ADDENDUM 03, DELTA 03 DATE 05.01.2026

PROJECT: Santa Rosa Freestanding Emergency Room

ARCHITECT'S PROJECT NUMBER:
225014.00

OWNER: HCA Florida Fort Walton-Destin Hospital

1 FIRE PROTECTION - FIRST FLOOR PLAN - NEW WORK
SCALE: 1/8" = 1'-0"

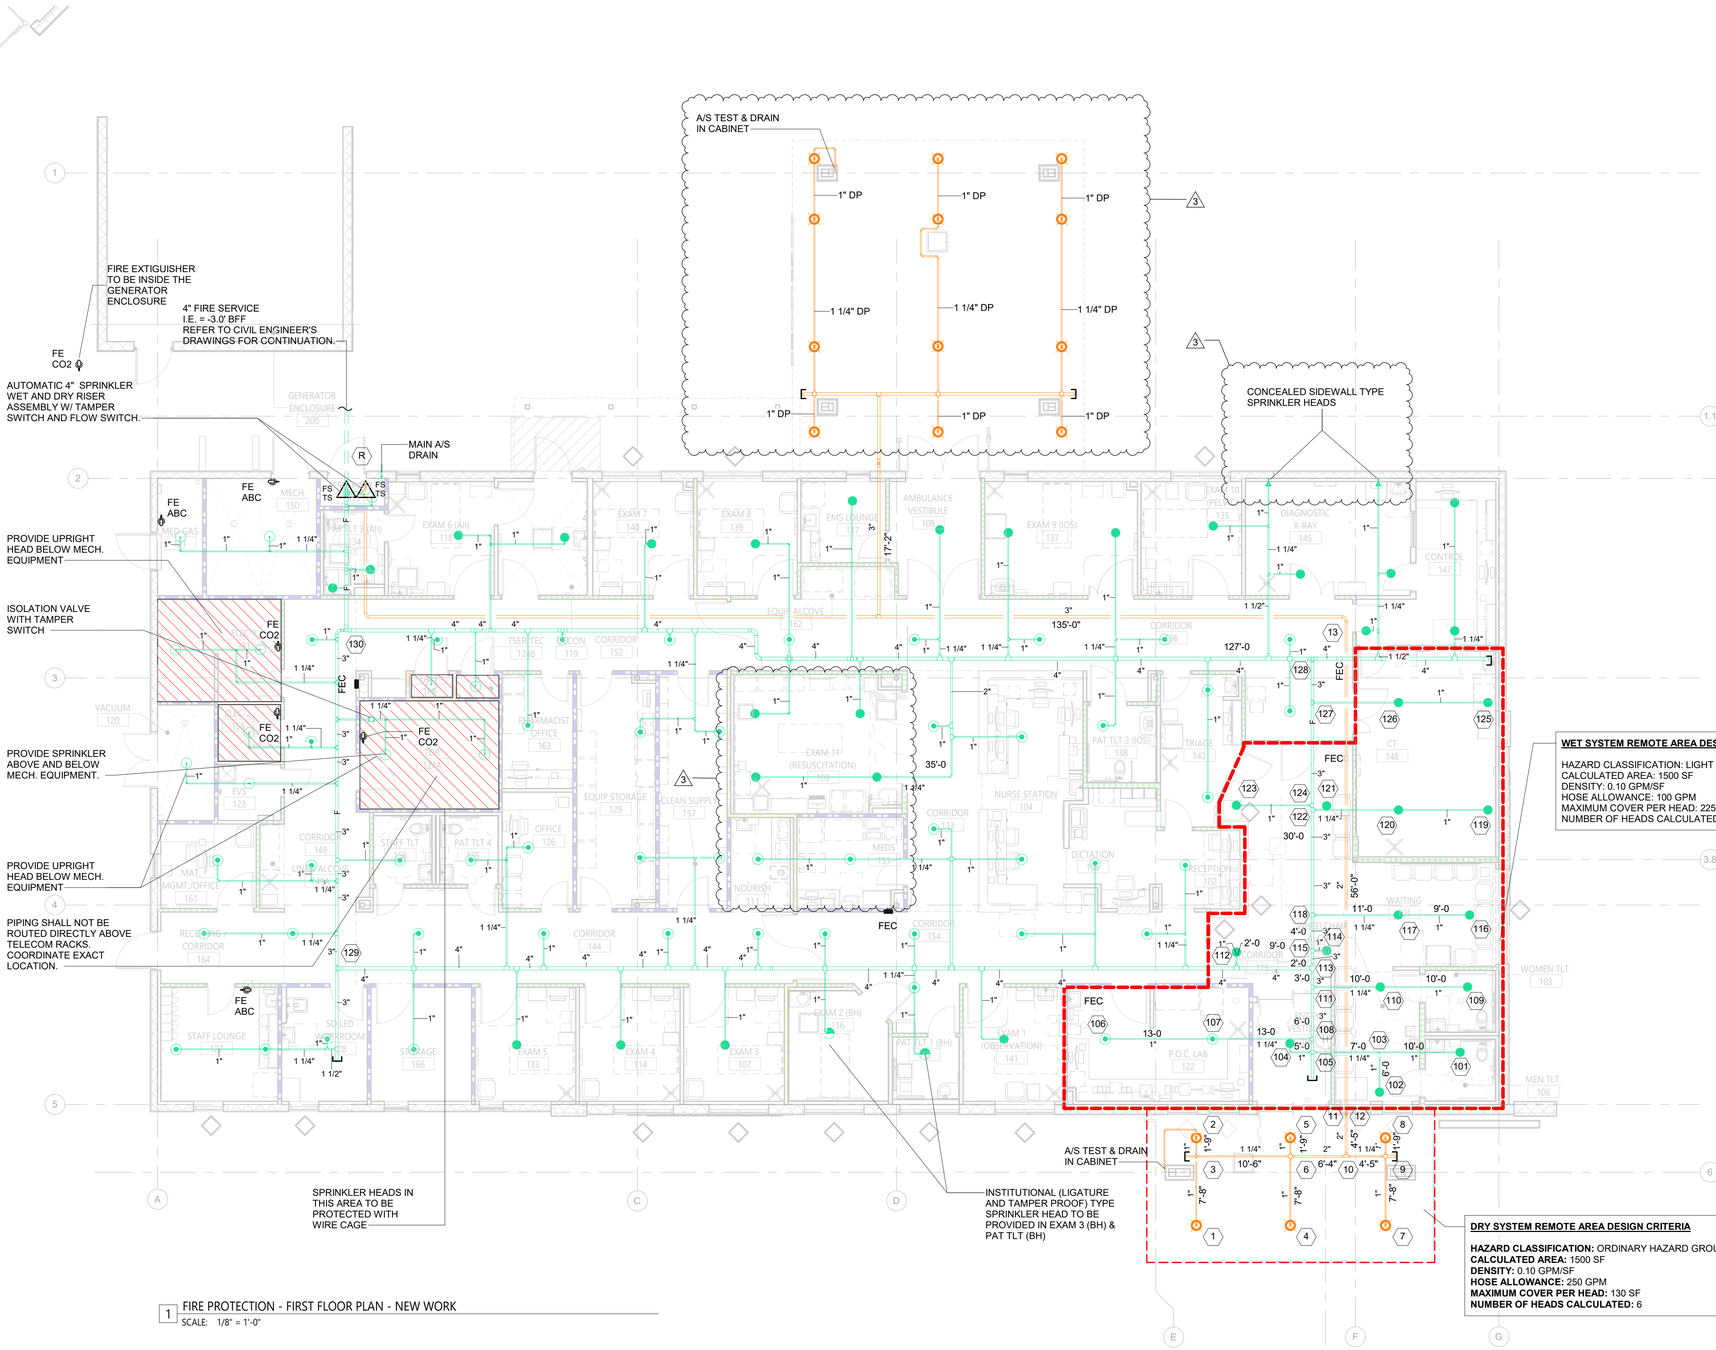
1. Revised canopy sprinkler layout per design coordination.
2. Added sidewall sprinkler heads to X-ray room 145 per design coordination.

1 PLUMBING - UNDERGROUND PLAN - NEW WORK
SCALE: 1/8" = 1'-0"

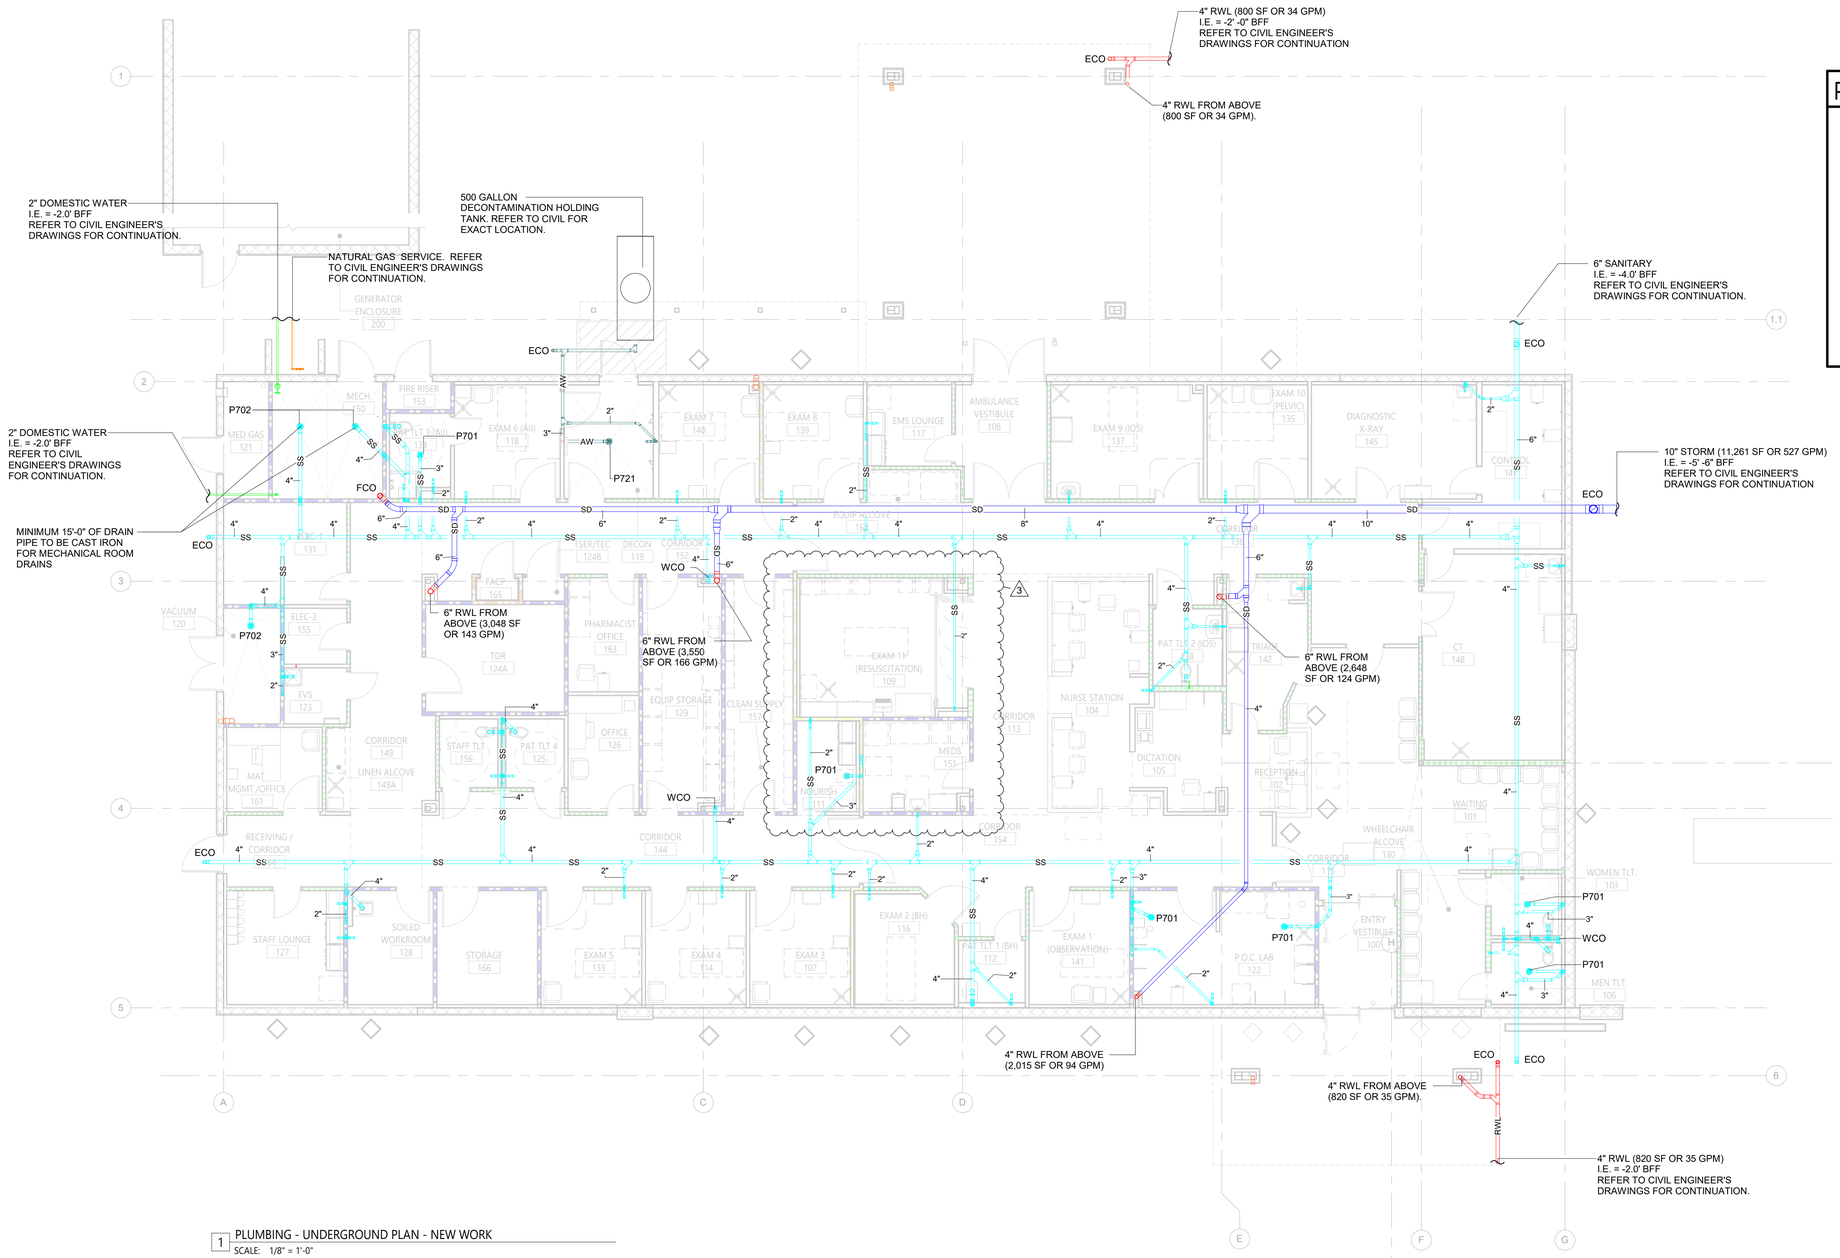
1. Revised underground sanitary routing to accommodate floor plan changes per architectural coordination.

1 PLUMBING - FIRST FLOOR PLAN - NEW WORK
SCALE: 1/8" = 1'-0"

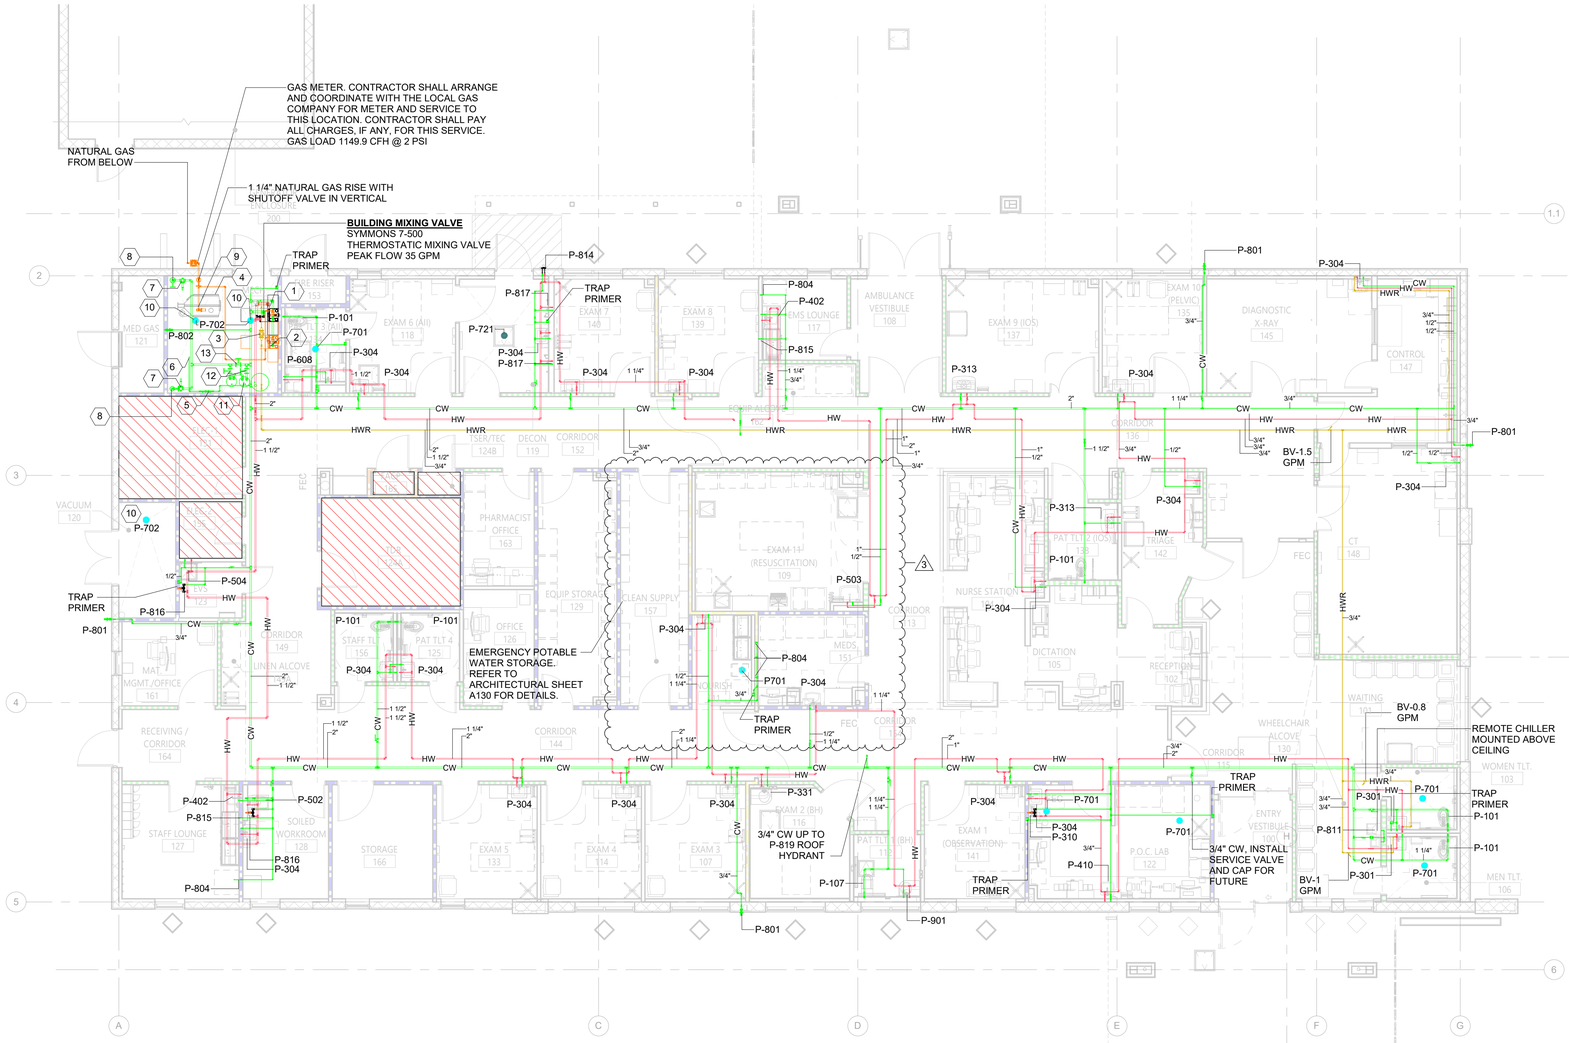
1. Revised domestic hot and cold water routing to accommodate floor plan changes per architectural coordination.

1 SANITARY - FIRST FLOOR PLAN - NEW WORK
SCALE: 1/8" = 1'-0"

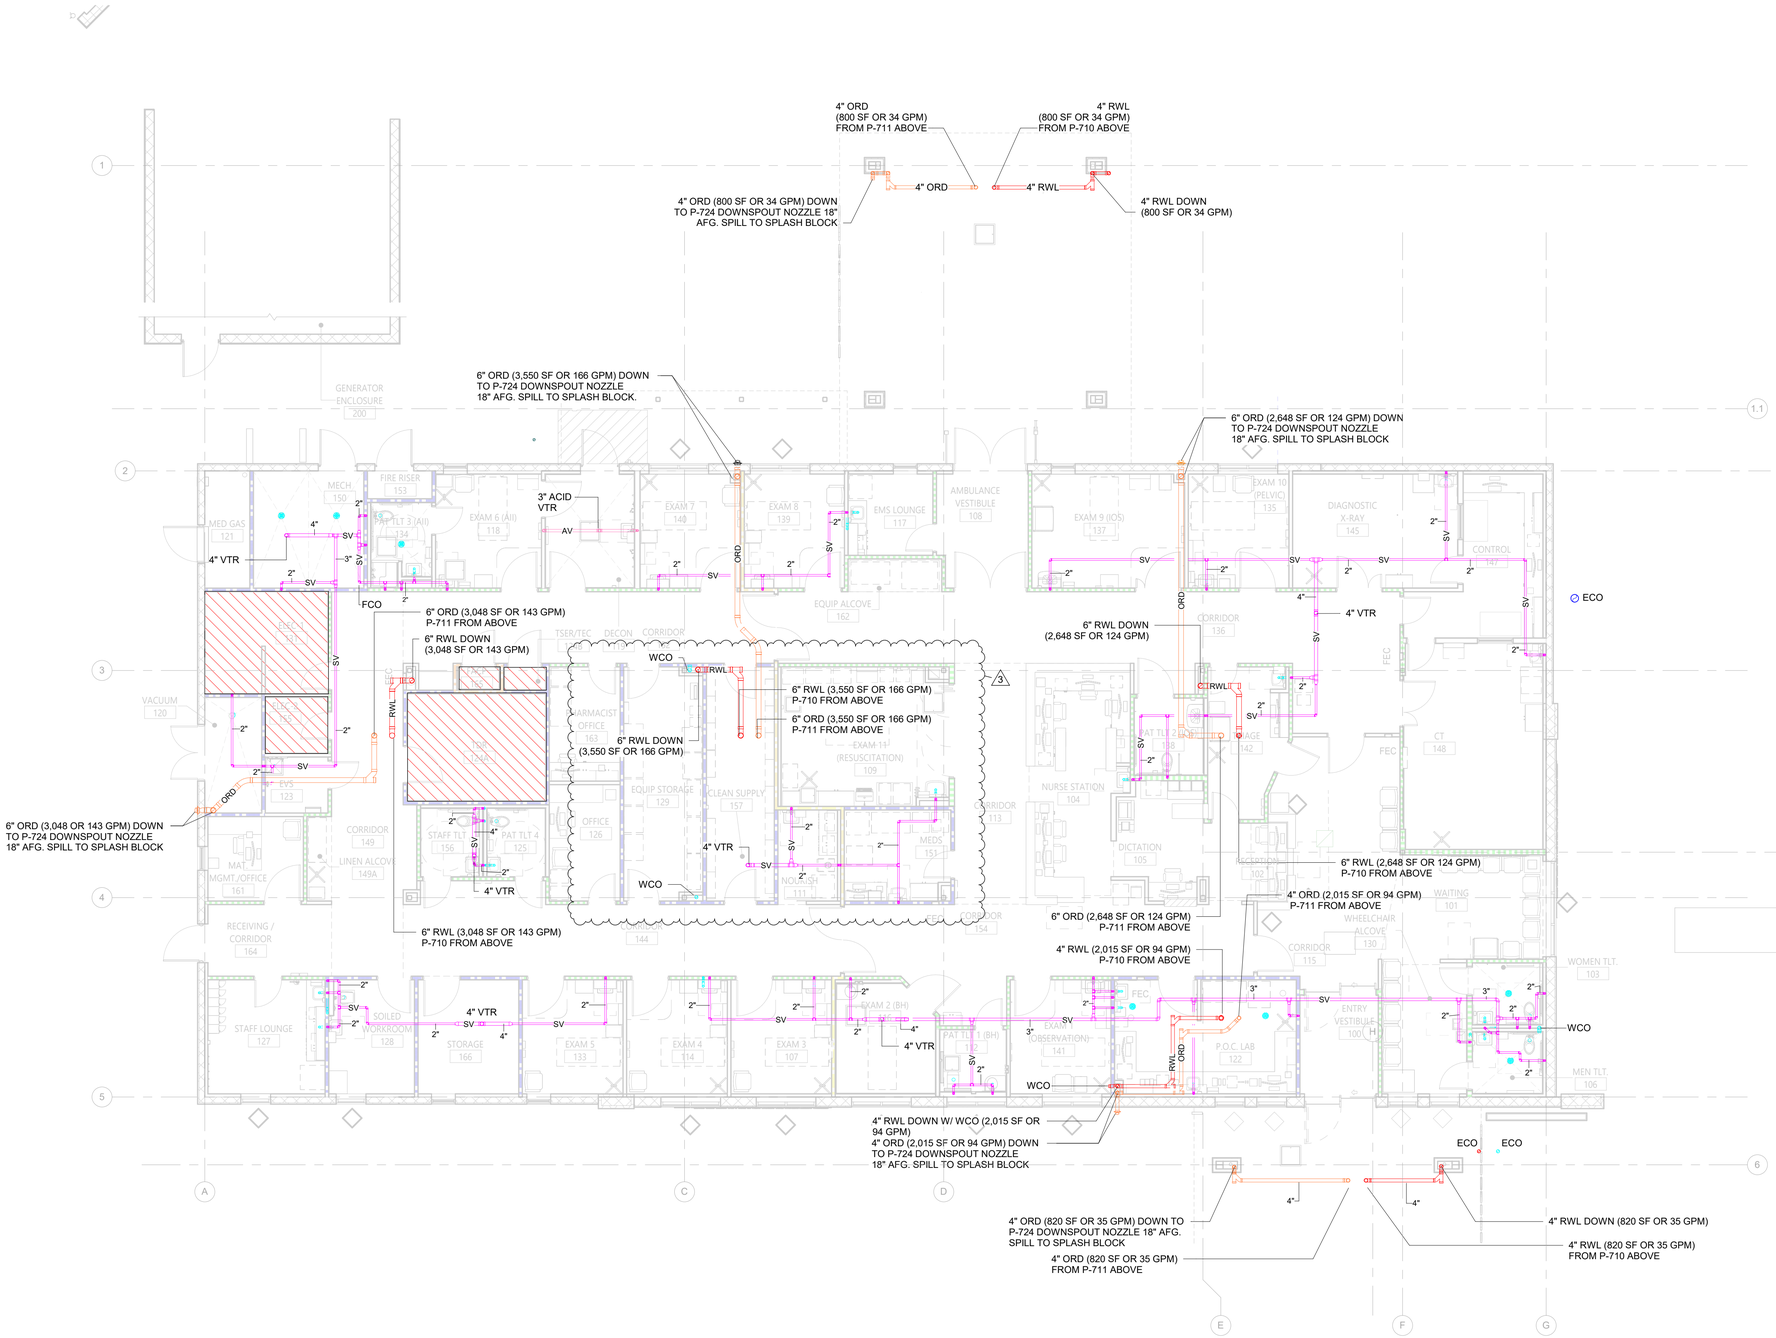
1. Revised above ground sanitary routing to accommodate floor plan changes per architectural coordination.

1 SANITARY - ROOF PLAN - NEW WORK
SCALE: 1/8" = 1'-0"

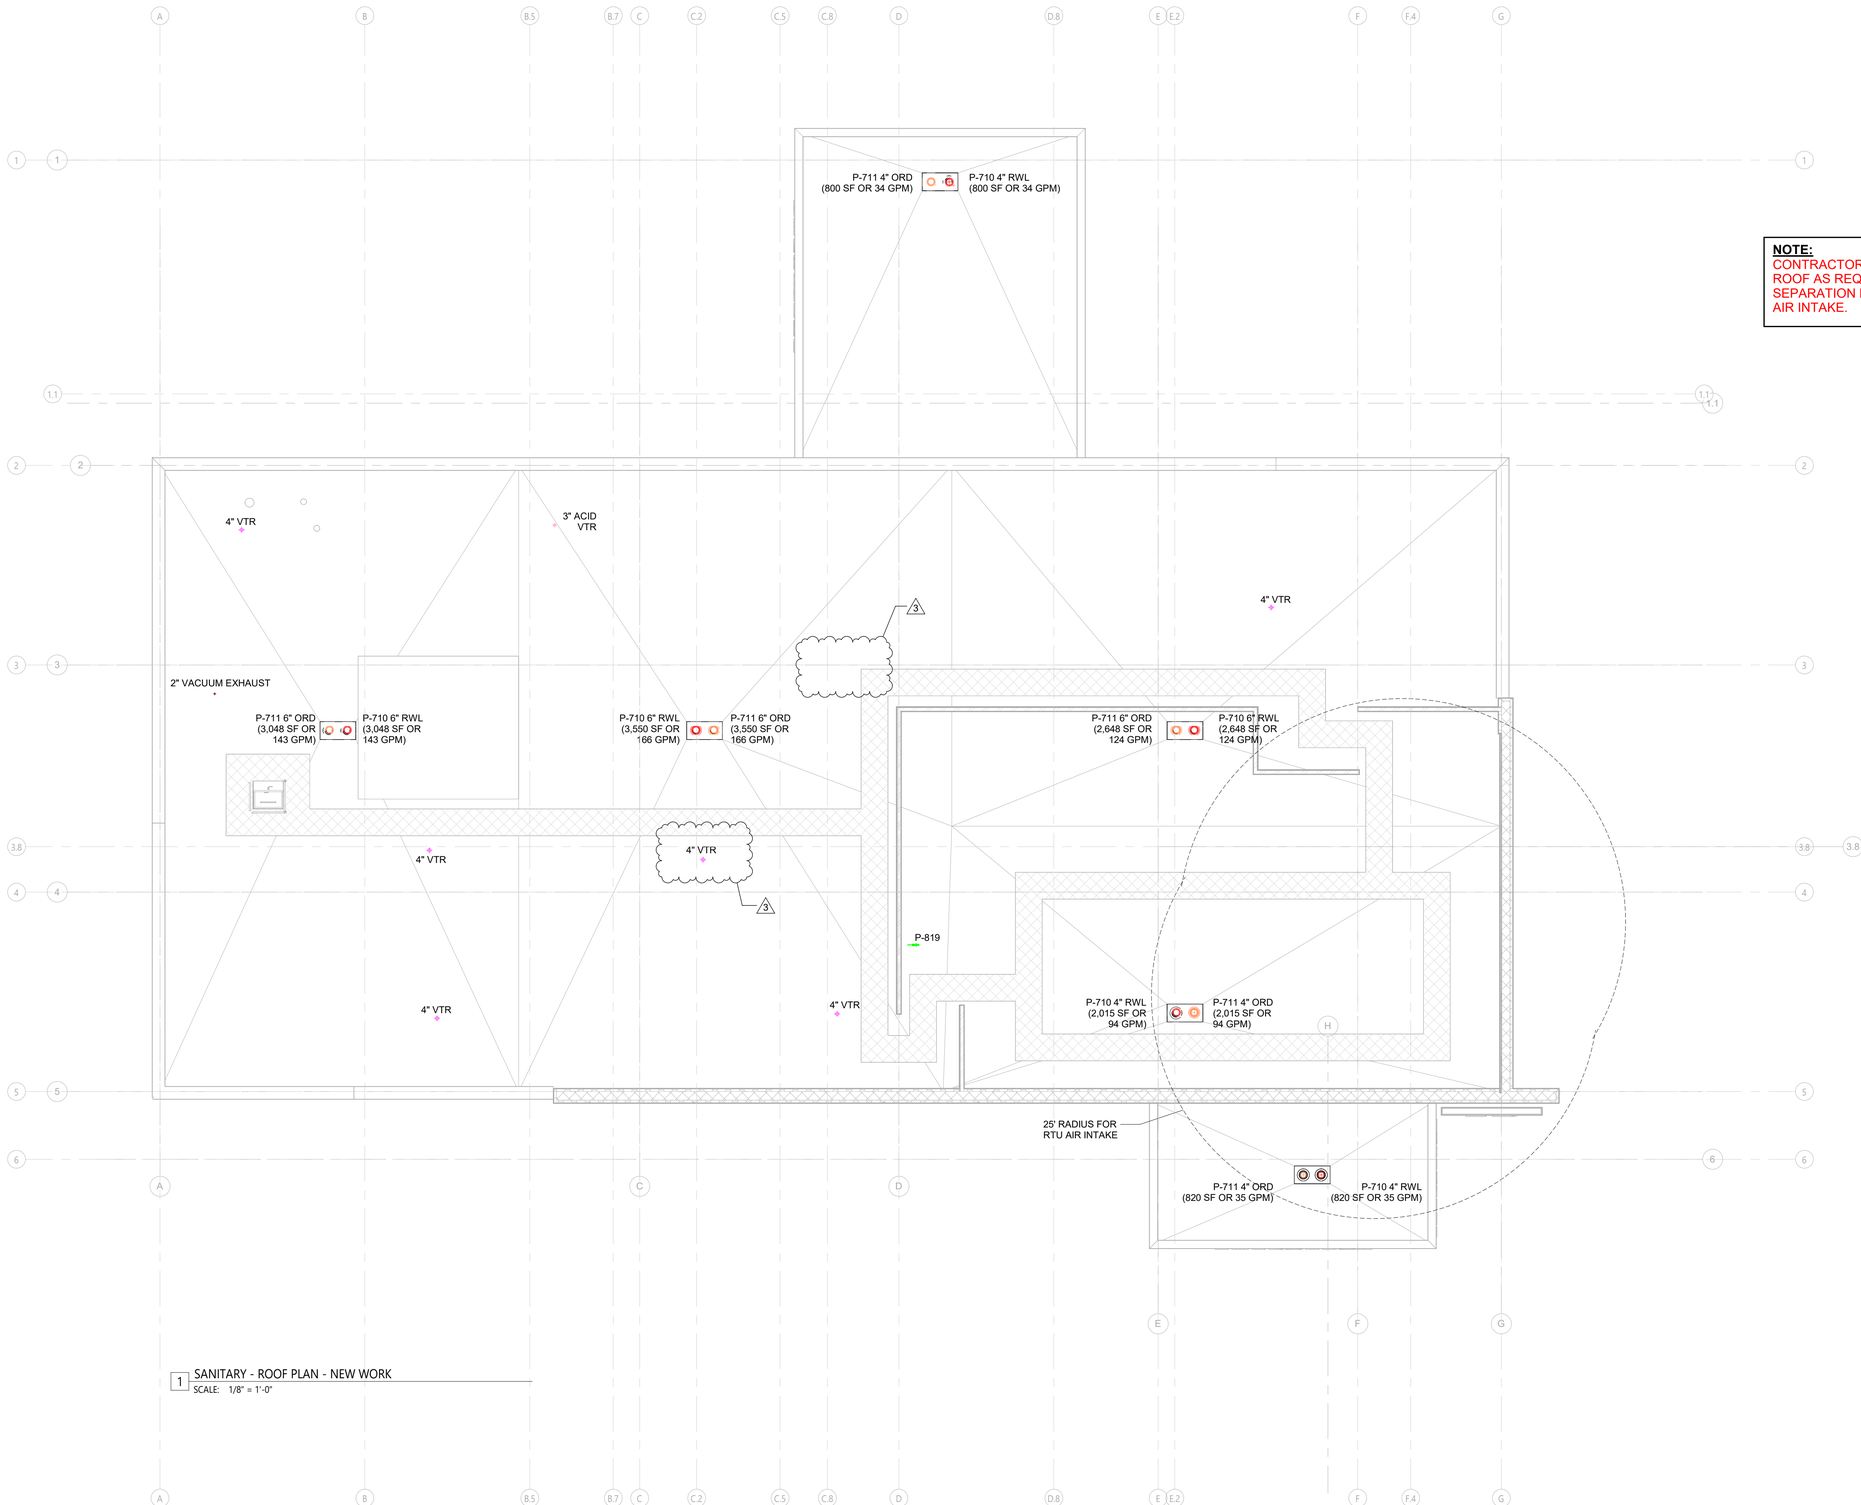
1. Revised 4” vent through roof location to accommodate floor plan changes per architectural coordination.
